Site Accessibility Evaluation

South Slope Recreation Area Open Space

Accessibility Evaluation

SUBJECT: South Slope Recreation Area Open Space Self-Evaluation

Finding: 1

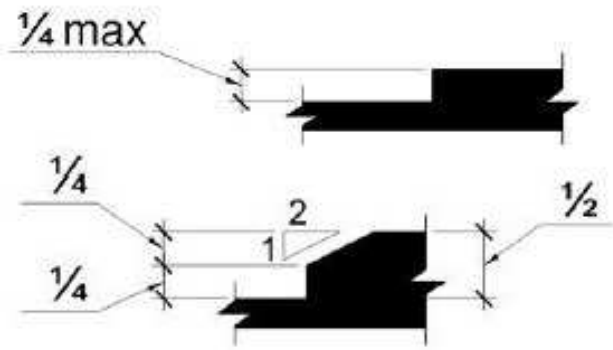
The walkway contains abrupt vertical edges and/or variations over a 1/4 inch.

The entrance into the men's and women's restroom has greater than 1/4" vertical displacement within 5' of the door.

We need to lower the slope from the door as well. The cost is to cover this as well.

Reduce vertical displacement to at or under 1/4".
